TITLE	YK-606 With Flange&With Cover Series(2P-3P)					
PART NO.	YK606xx1xx00G			DWG NO.	8YK0006-606	
APPROVED	CHECKED	DESIGNED	DRAWN	CUST NO.		Tolerance
		Jacky 2012.11.17	Jacky 2012.11.17	UNIT: mm	SCALE: NONE	X. ±0.50 X.X ±0.30 X.XX ±0.10 X° ±1°
				SHEET: 01/01	REV.: F

TITLE	YK-606 With Flange&With Cover Series(4P-30P)				
PART NO.	YK606xx1xx00G			DWG NO.	8YK0001-606
APPROVED	CHECKED	DESIGNED	DRAWN	CUST NO.	
		Airy min 2014.08.25	Airy min 2014.08.25	UNIT: mm / SCALE: NONE / SHEET: 01/01 / REV.: H

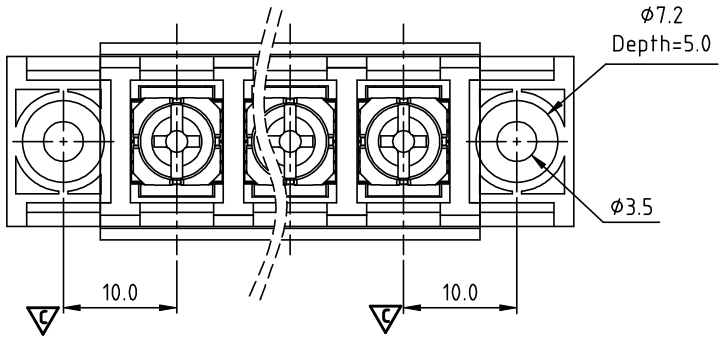
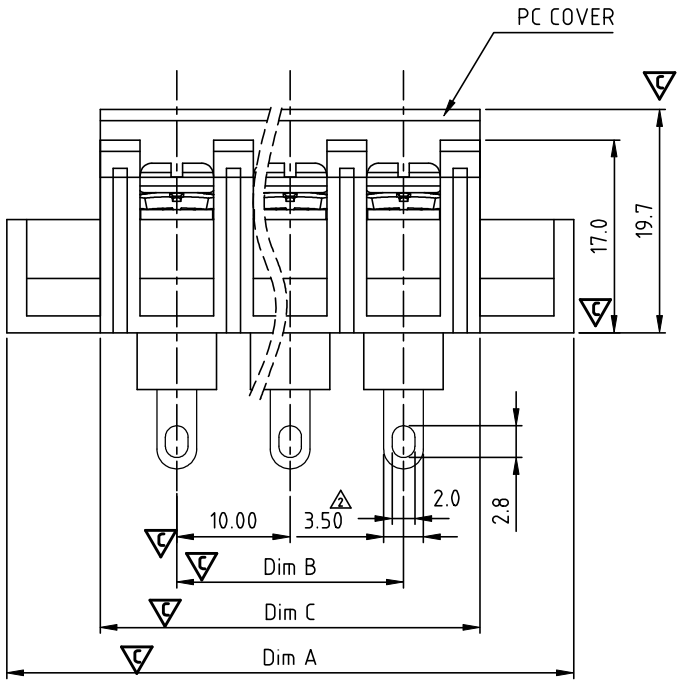
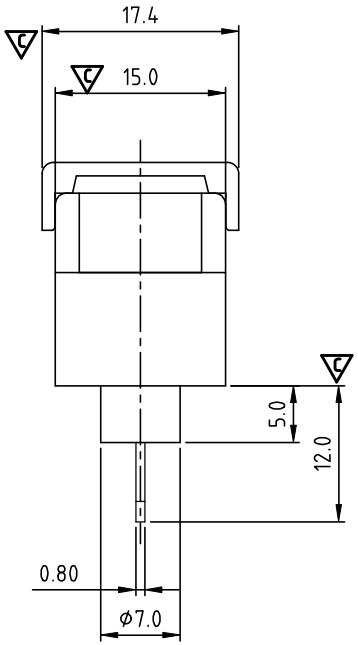
SIGN	DATE	DESCRIPTION	APPROVER
1	2/07'06	Part No. changed	Tony
2	7/11'06	Dimesion changed from 3.6 to3.5	Tony
3	2006.08.3	Screw torque value changed from 10.4Lb-in to 12Lb-in	梁仁松
4	2006.08.3	Approval changed	梁仁松
5	3/30'09	Temperature changed from -40~105°C to -40~115°C	JODY
6	11/17'12	Change the screw plating specification	Jacky
7	11/17'12	Change the dimensional tolerance	Jacky

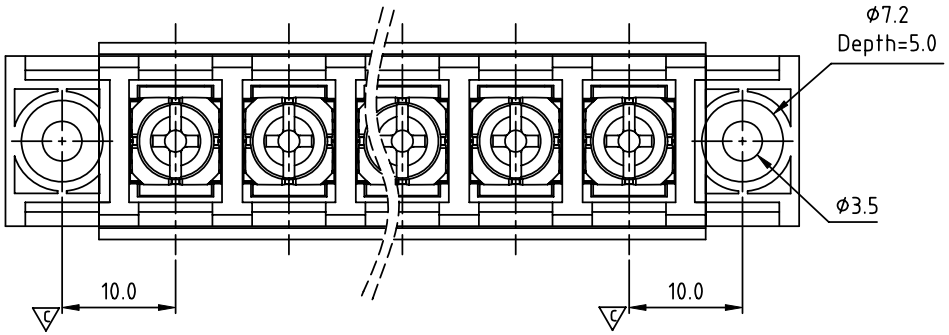
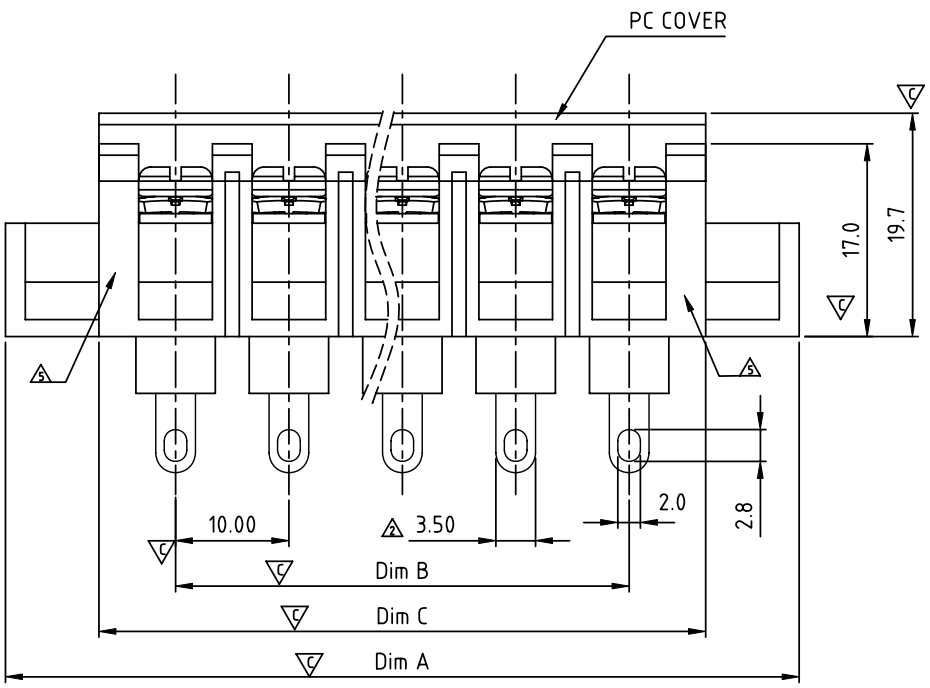
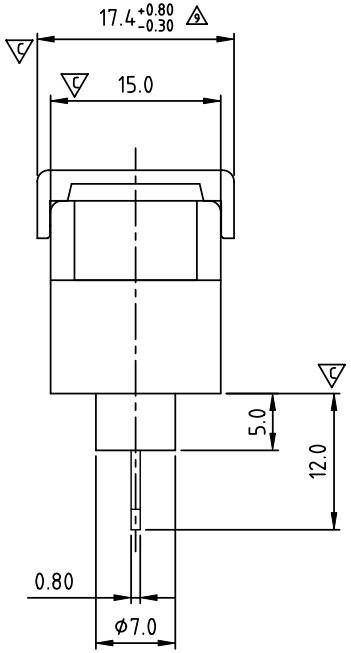
SIGN	DATE	DESCRIPTION	APPROVER
1	2/07'06	Part No. changed	Tony
2	7/11'06	Dimesion changed from 3.6 to3.5	Tony
3	2006.08.3	Screw torque value changed from 10.4Lb-in to 12Lb-in	梁仁松
4	2006.08.3	Approval changed	梁仁松
5	3/30'09	Structure changed	JODY
6	3/30'09	Temperature changed from -40~105°C to -40~115°C	JODY
7	11/17'12	Change the screw plating specification	Jacky
8	11/17'12	Change the dimensional tolerance	Jacky
9	08/25'14	The dimensional tolerance is changed from 17.4 ± 0.30 to $17.4^{+0.80}_{-0.30}$	Airy min
THIS IS CAD DRAWING, DO NOT REVISE MANUALLY!!!
